The County of Caldwell will receive bids for the Caldwell County Evacuation Center GLO Contract No. 22-085-024-D265 by **3:00 pm** on **July 26, 2024**, at the Caldwell County Courthouse, 110 S. Main St. Lockhart, Texas 78644. Bids must be addressed to: **Hoppy Haden, County Judge**. The bids will be publicly opened and read aloud on July 26th, 2024, at 3:00 pm at 110 S. Main St. Lockhart, TX 78644.

RE: Caldwell County Evacuation Shelter – Addendum 01

RE: Caldwell County Evacuation Shelter – Addendum 02

CALDWELL COUNTY
EVACUATION SHELTER
LULING, TEXAS
PM: DR: GP/OF
PROJECT:
(PW) 1911-004
SHEET:
C7.0
OVERALL
UTILITY PLAN

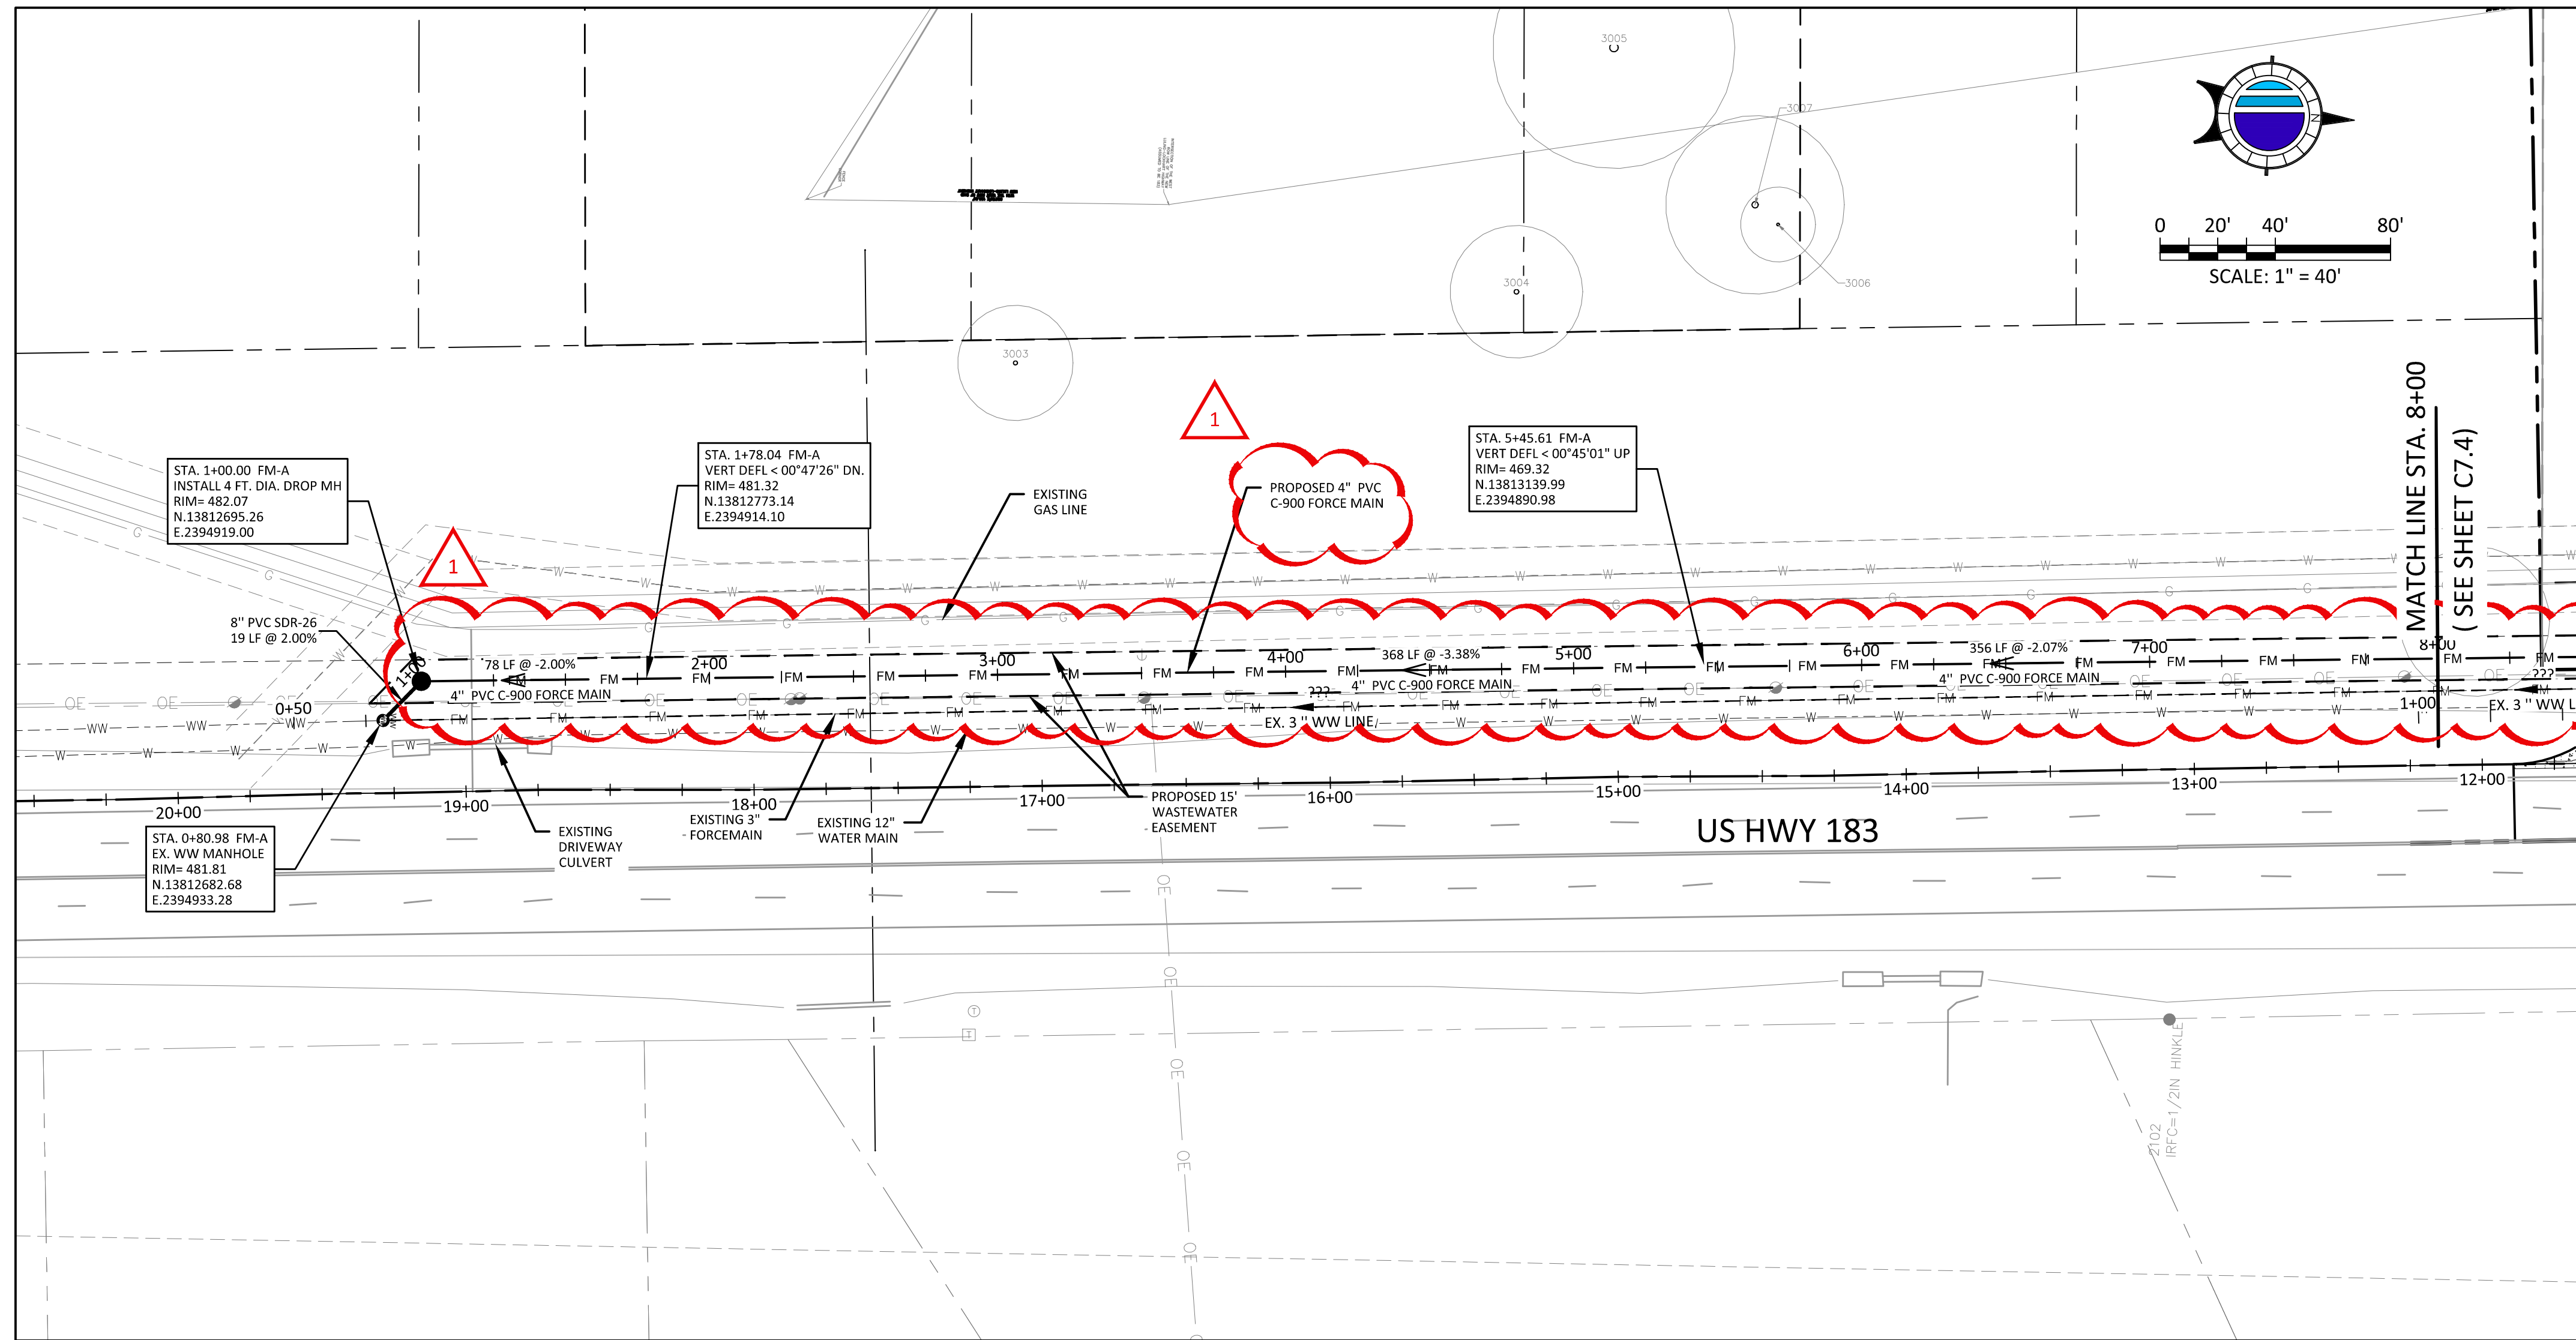
Response: Please see the attached pump recommendation for no-clog pump selection. The lift station has been designed based on 480V/3 phase power, 110 gpm flow rate, and total design head of 40ft. Force main has been revised to 4" diameter per City of Luling requirements, revised FM sheets attached.

PROPOSED 4" PVC C-900 WASTEWATER FORCE MAIN. SEE SHEET C7.3 AND C7.4

PROPOSED LIFT STATION
STA. 10+30.54 END OFFSITE 4" PVC C-900 WASTEWATER FORCE MAIN = STA. 1+00 BEGIN WWL-A
RIM= 467.55
FL(IN)= 455.00 (8" PVC SDR-26)
FL(OUT)= 457.00 (4" PVC C-900 FORCE MAIN) (SEE UTILITY NOTE 2, THIS SHEET) (SEE SHEETS C7.3 AND C7.4 FOR PROFILE) AND SHEET C7.8 FOR LIFT STATION DETAIL
